Agenda Item: Administrative Amendment – Change in Conditions – Carotek

DATE: October 19, 2016

CAROTEK STORAGE BUILDING EXPANSION #2
710 SAM NEWELL ROAD
MATTHEWS, NC 28106

EXISTING CONDITIONS ZONING SITE PLAN

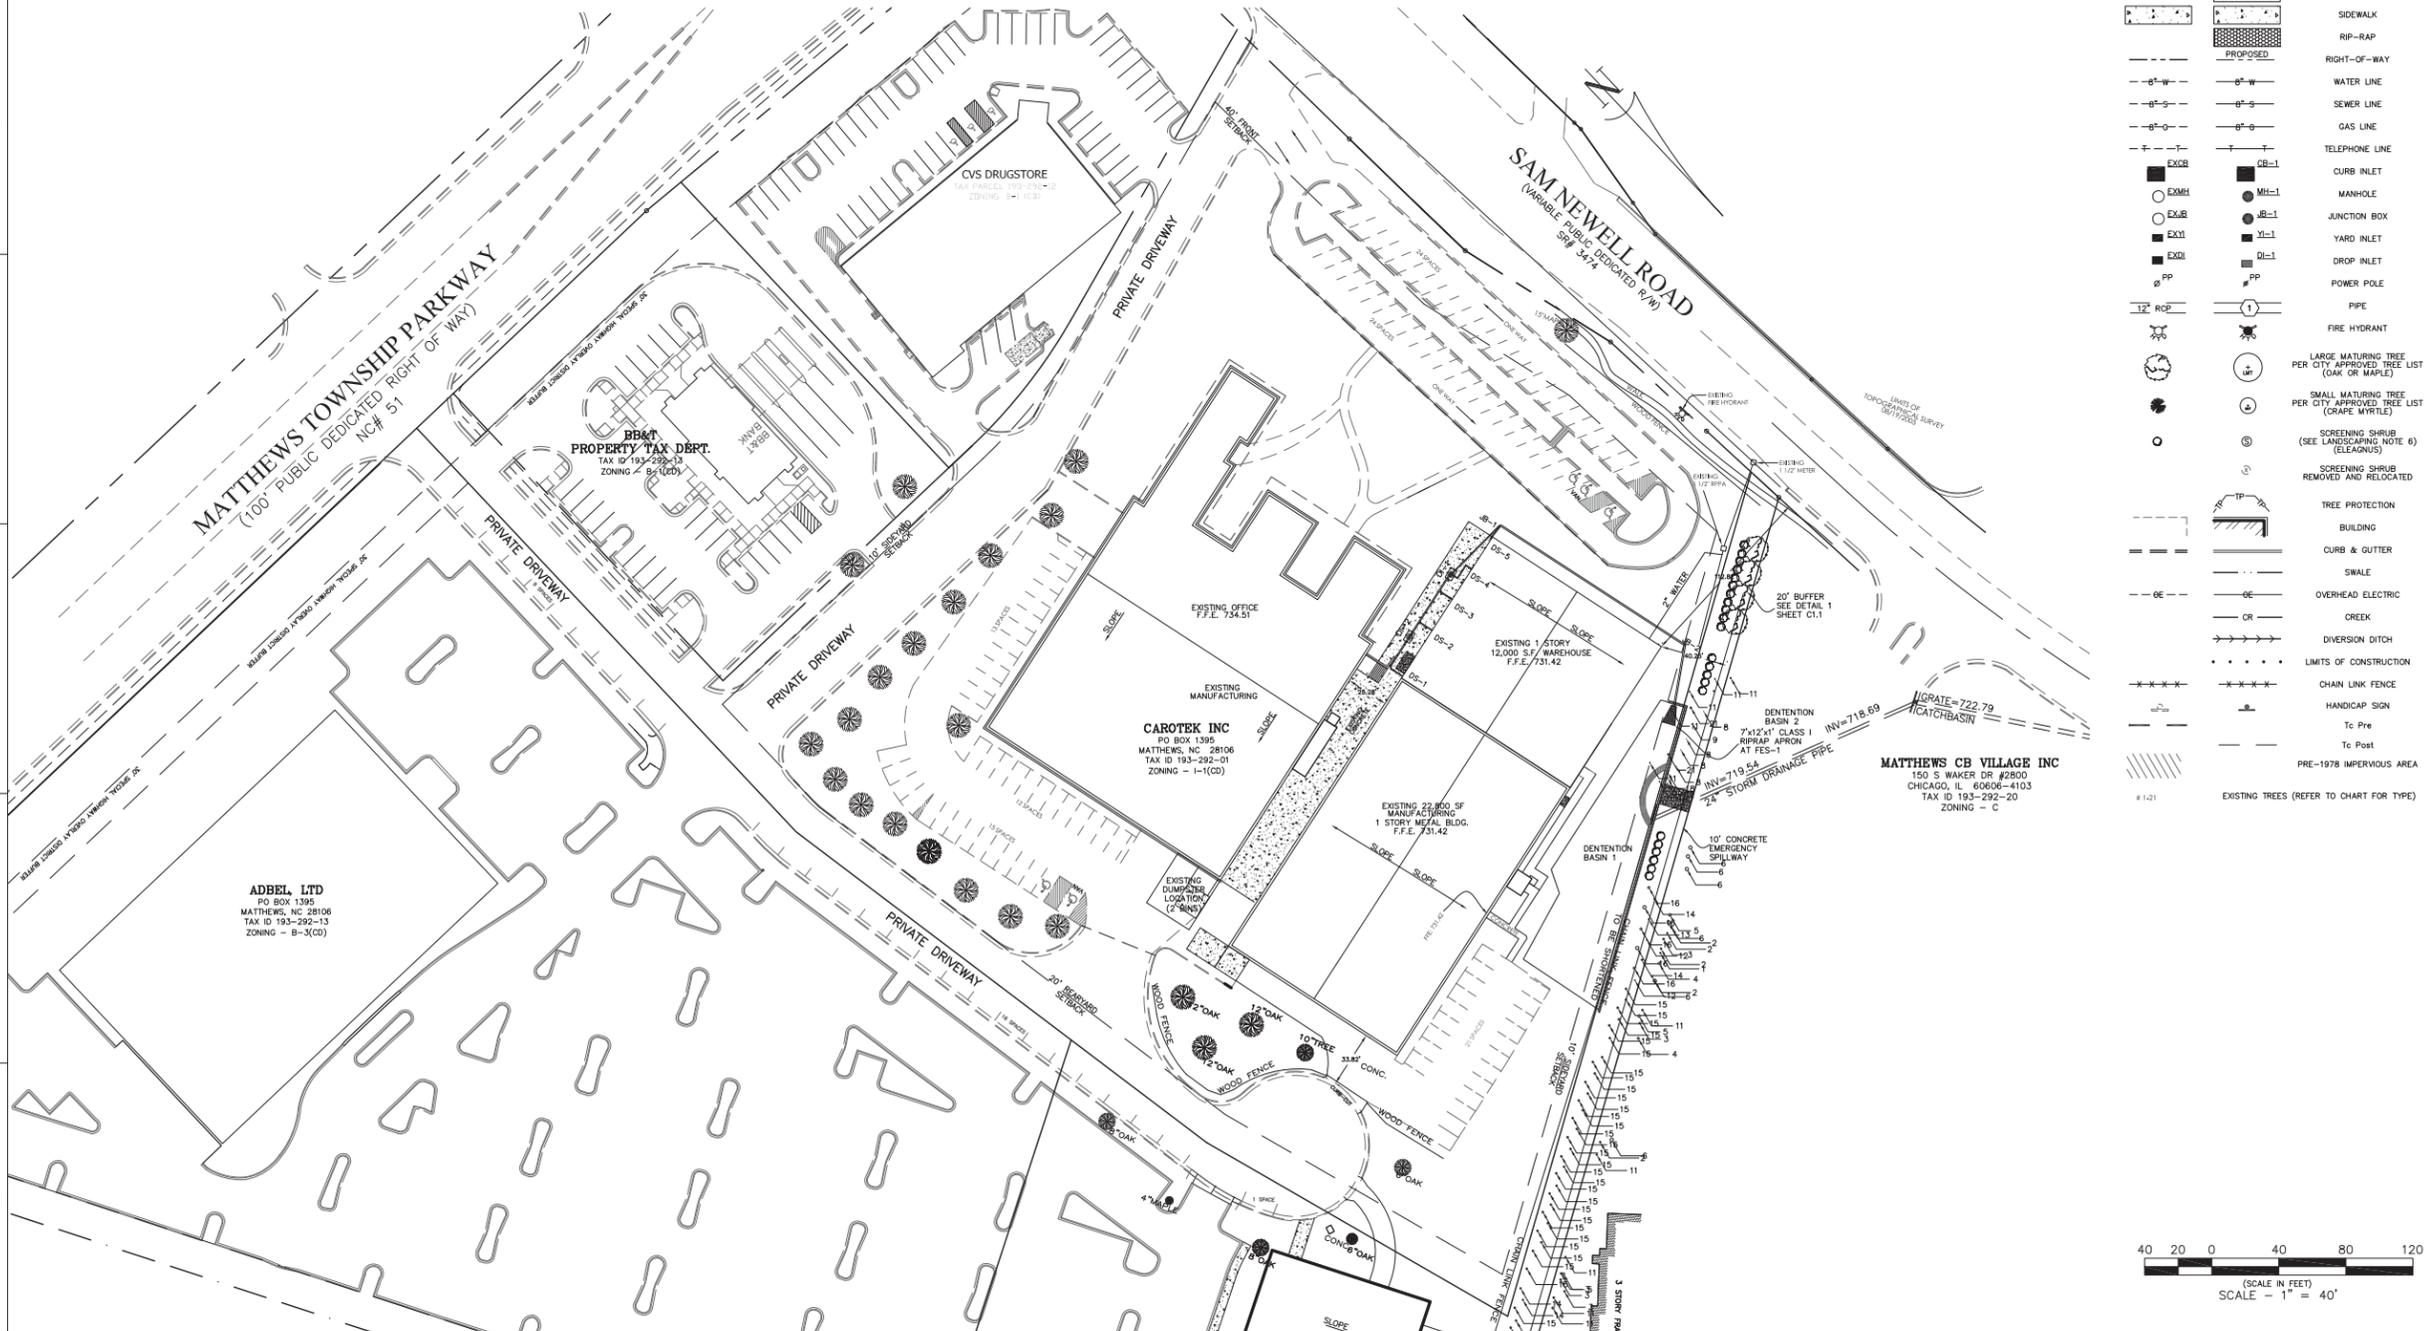
The 2006 Highway Overlay and Landscape review plans show future 12,000 sq. ft. addition to the Carotek facility towards Sam Newell, with 21 parking spaces on the north side of the building. The addition and parking lot were installed sometime after that. In June of 2009, property lines between the medical offices and Carotek were redrawn, and “on-street” parking was established along the private drive, Aubrey Bell Drive (see attached). The “on-street” parking spaces are part of the medical offices required parking.

Carotek is requesting to place a building when parking spaces currently exist, add parking on their side of Aubrey Bell Drive, and parking along the unnamed private drive behind BB & T Bank.

PROPOSED EXPANSION ZONING SITE PLAN
CAROTEK STORAGE BUILDING EXPANSION #2
710 SAM NEWELL ROAD
MATTHEWS, NC 28106

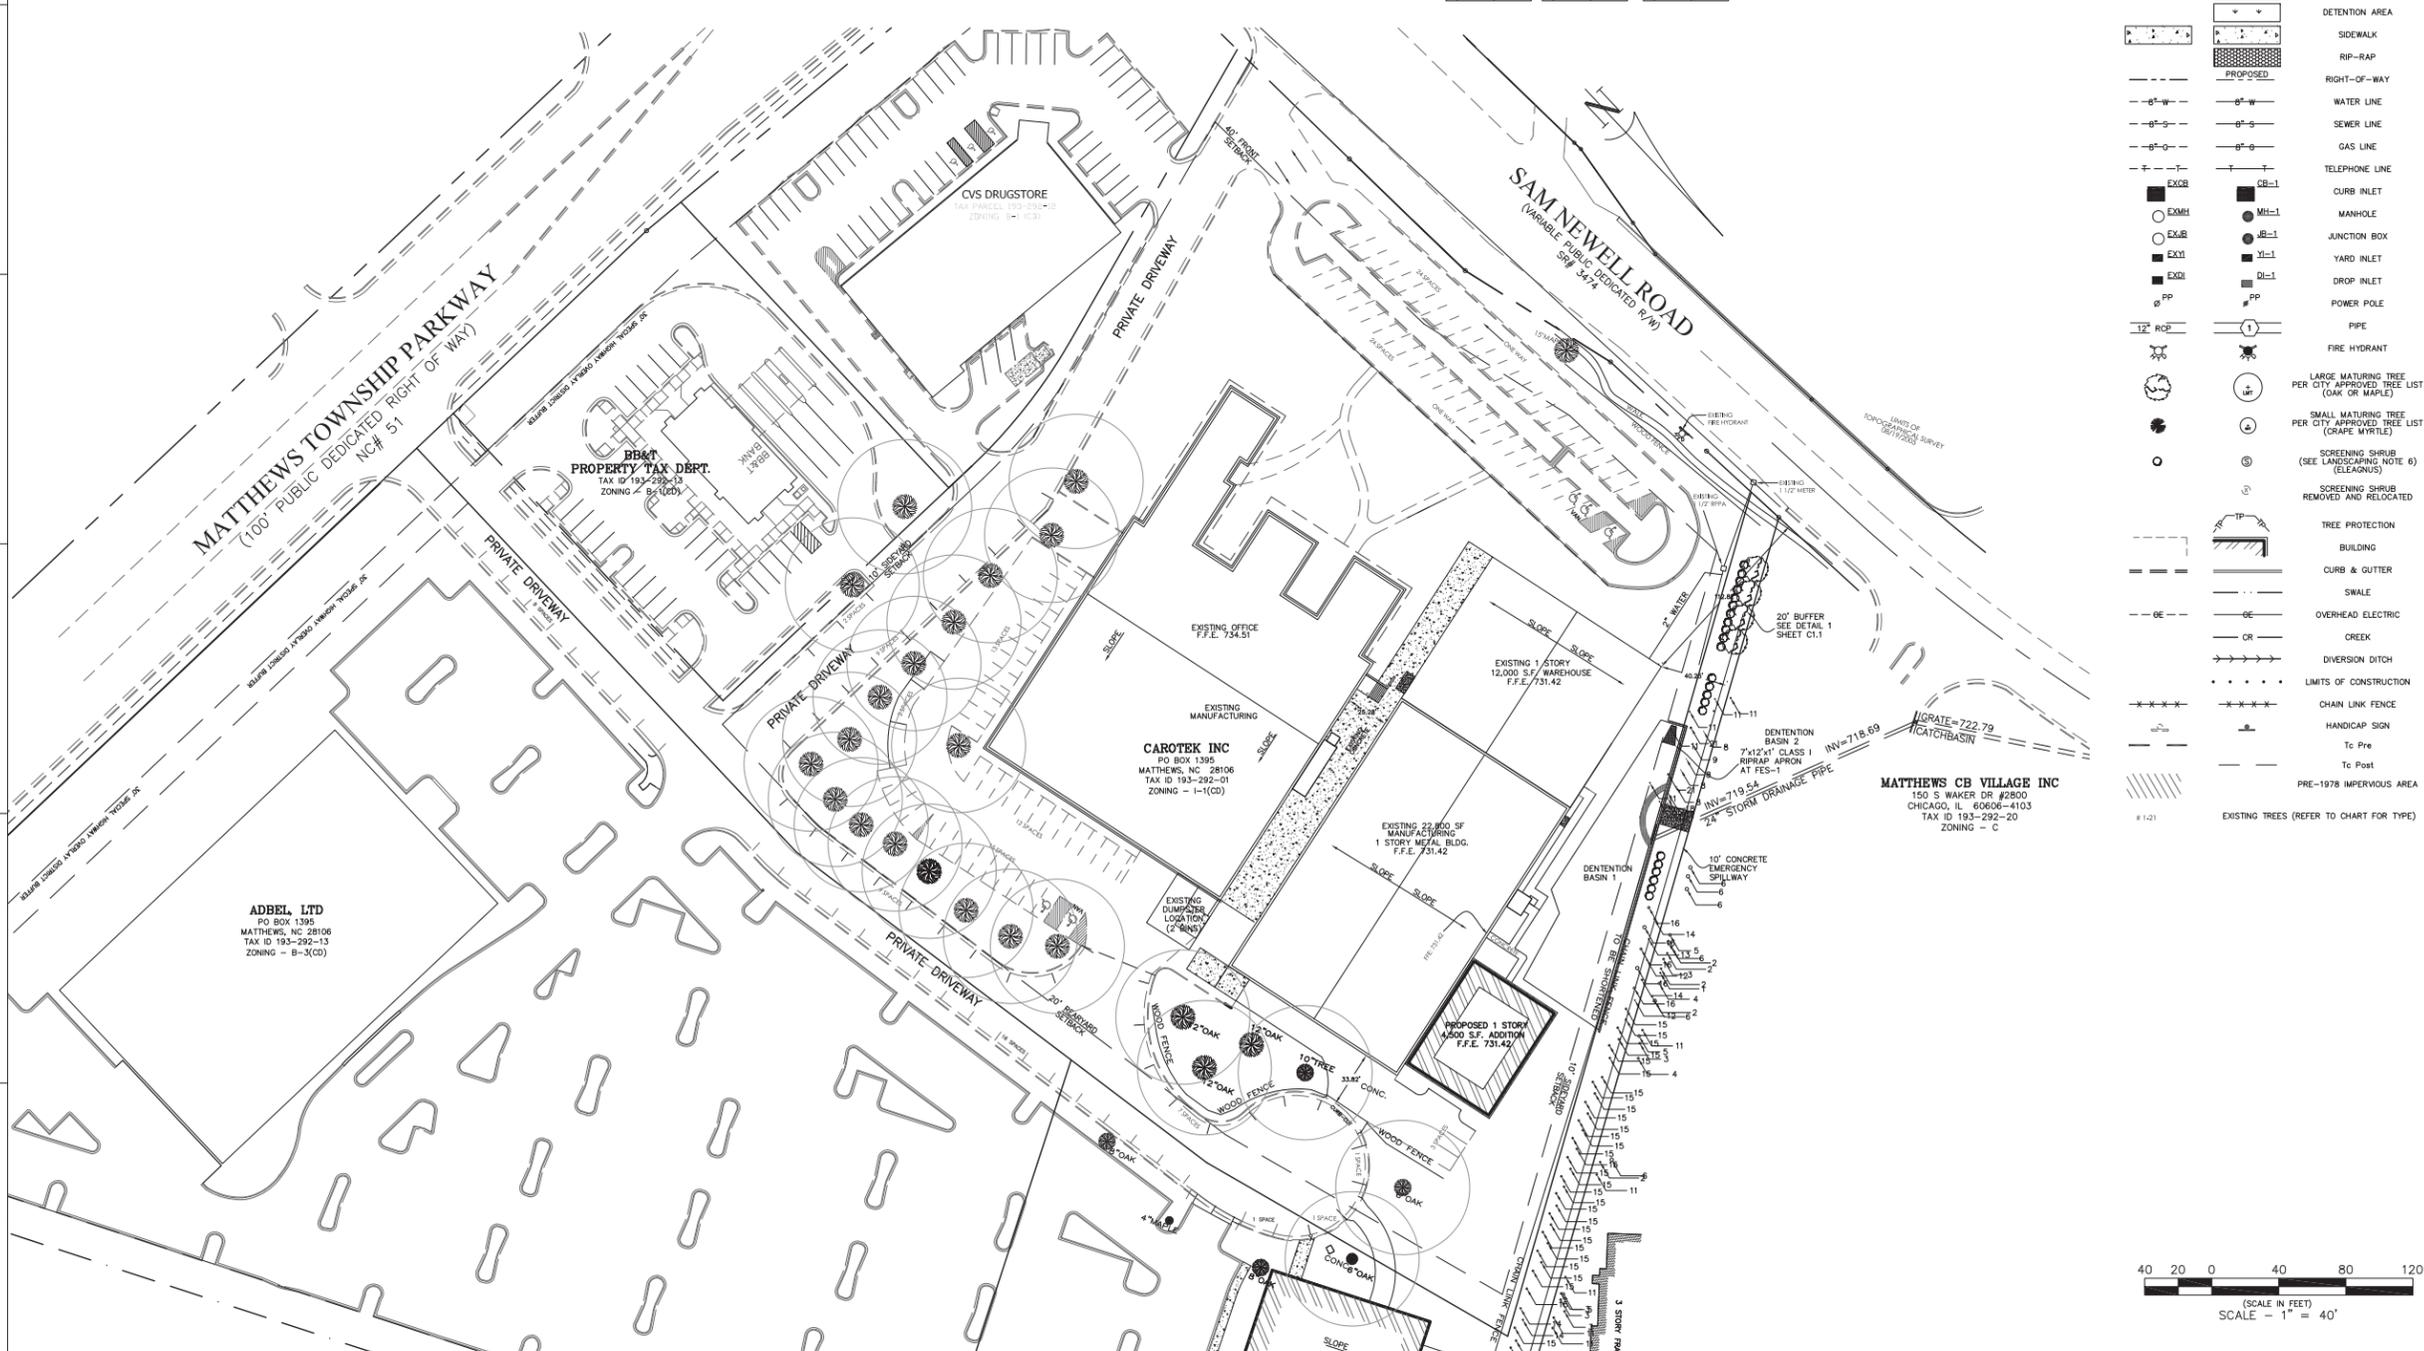
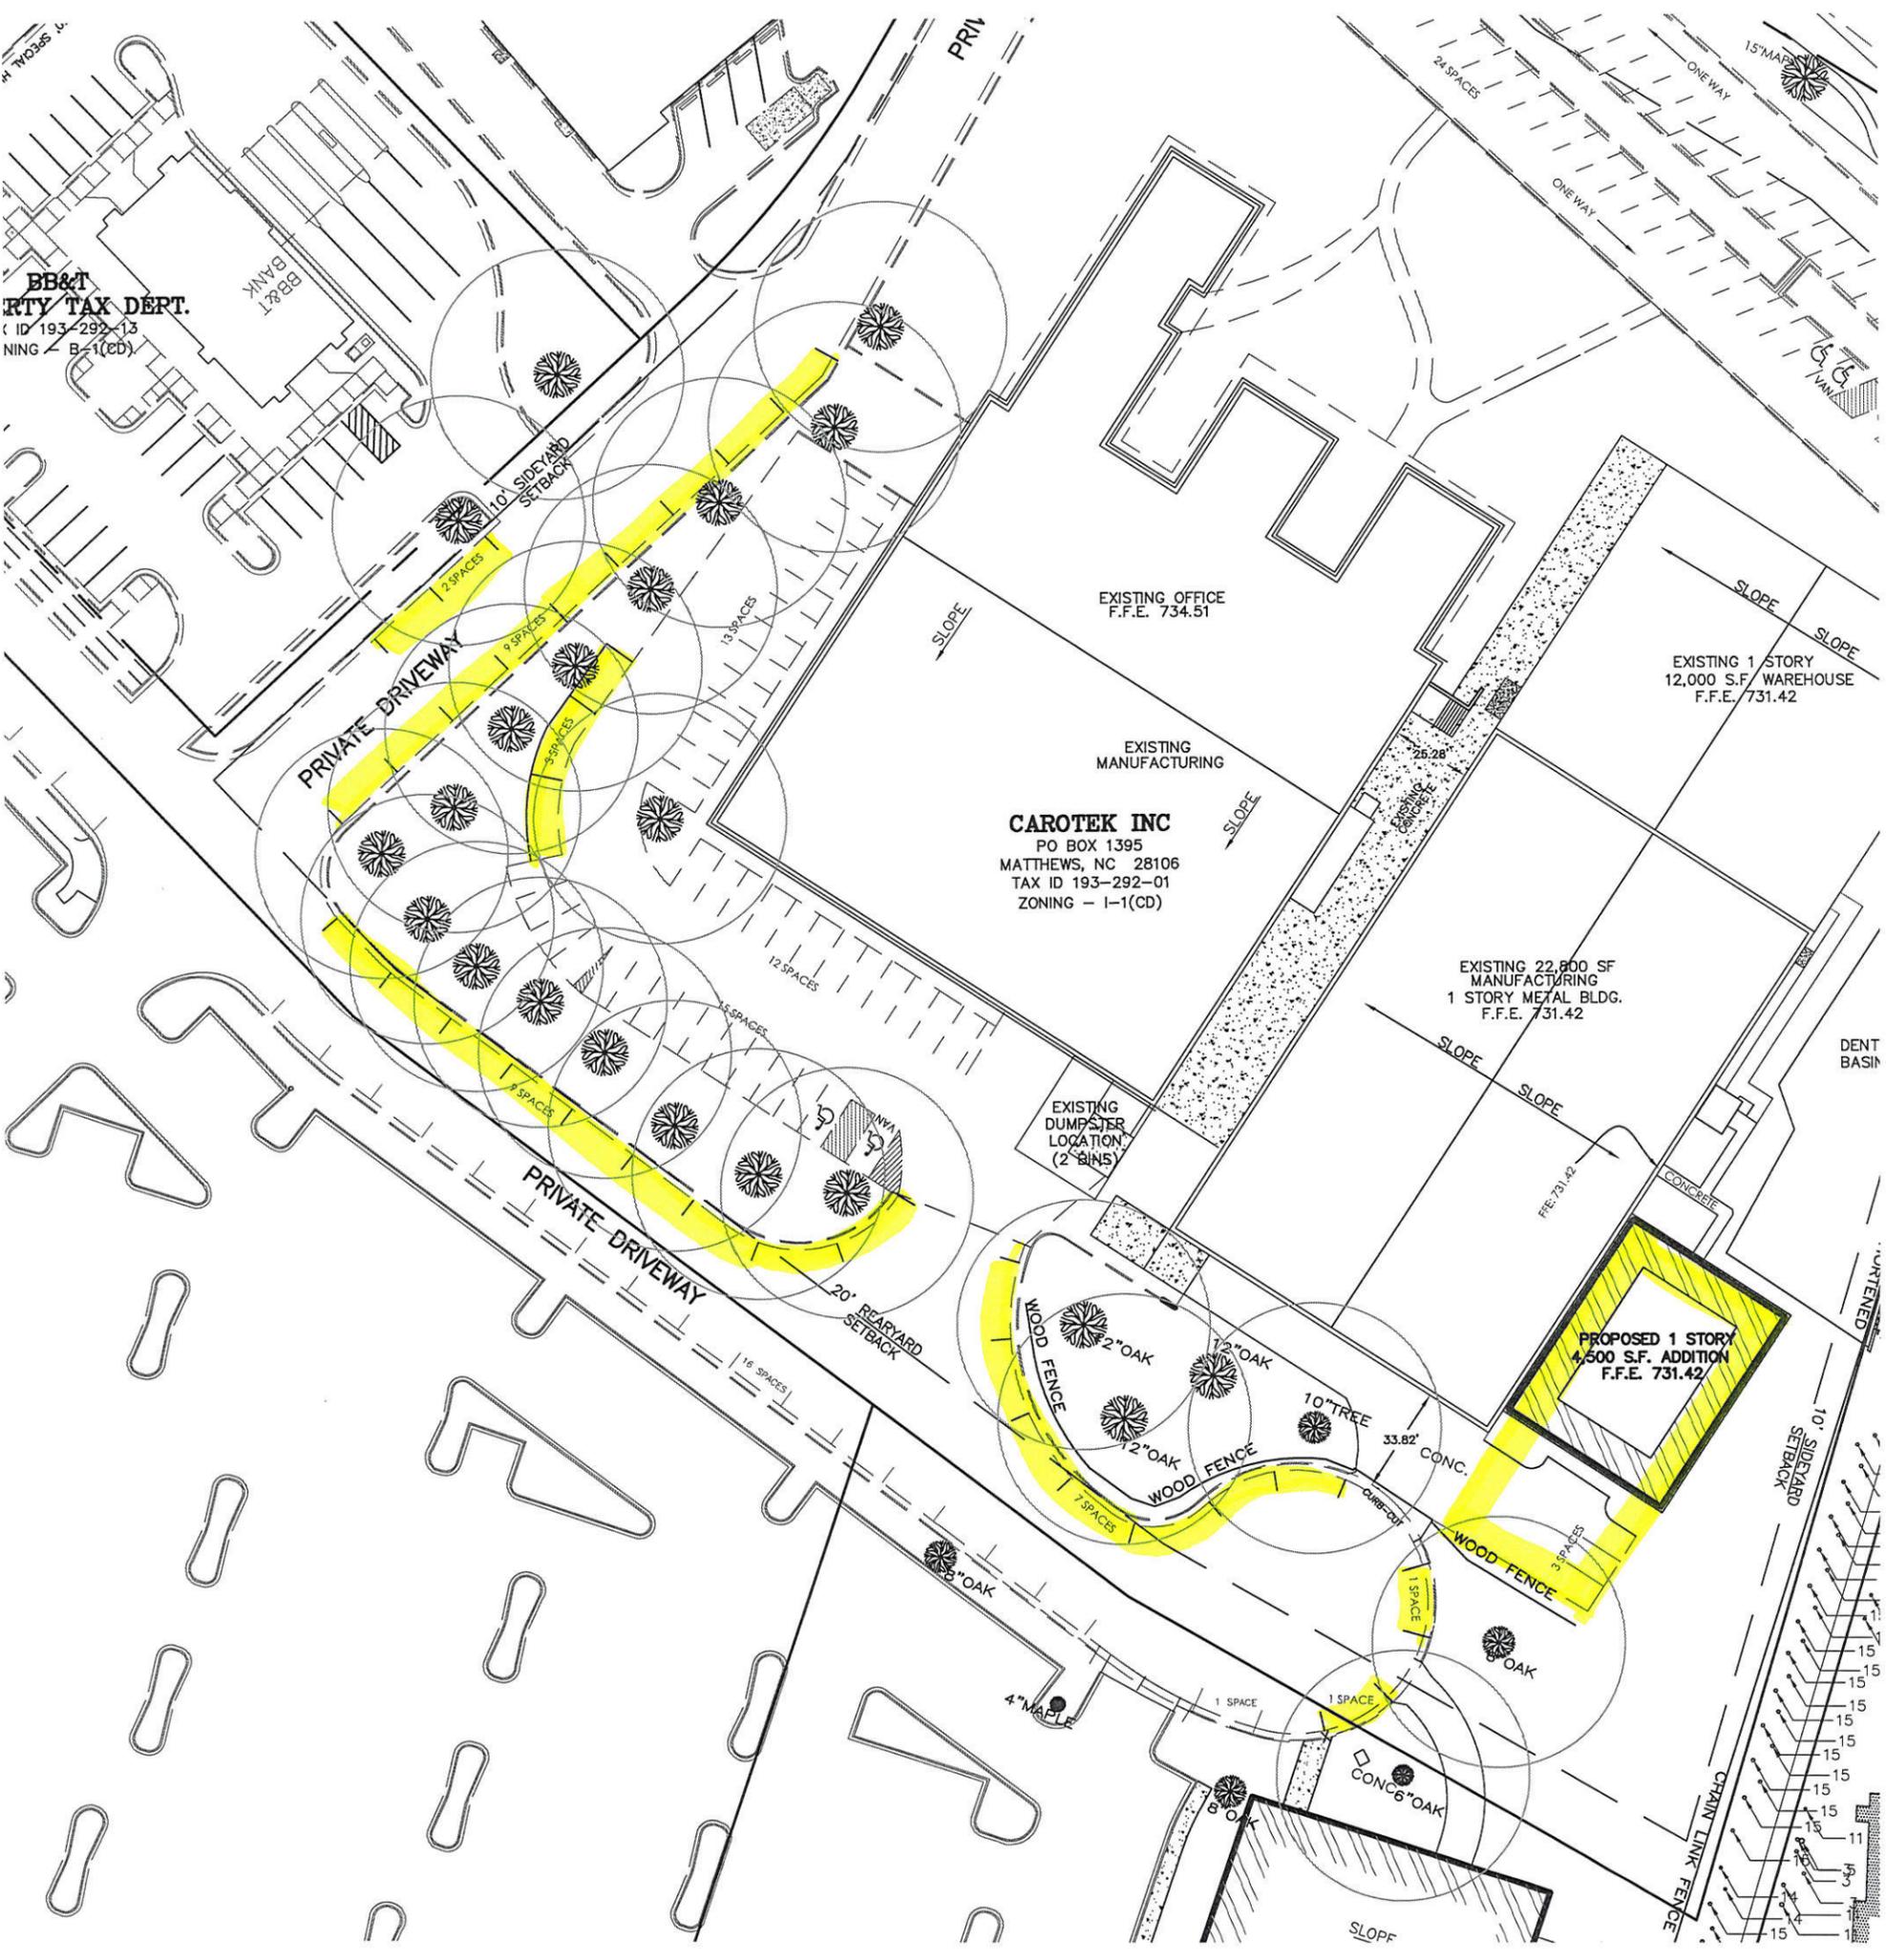
- A. Remove 18 existing parking spaces on the north side of the facility.
- B. Add a one story 4,500 sq. ft. building for manufacturing storage.

Currently 21 parking spaces are located where the applicant is requesting to place the building. Three (3) parking spaces will remain in this area.

- C. Add 18 parking spaces along Aubrey Bell Drive on the back side of their property.
- D. Add 11 parking spaces on their property along the unnamed drive (2 directly behind BB & T and 9 on the other side of drive closest to manufacturing facility).

- E. Add 3 parking spaces on the south corner of the property (not on private drives).

Existing parking is at 109 spaces; with the proposed changes, there will be 123 spaces available to Carotek on their property.

No trees will be removed in order to install the building or additional parking. All new parking spaces meet Matthews standards for size and location to trees.

Staff recommends the Planning Board approve the proposed change in conditions for Carotek as presented.
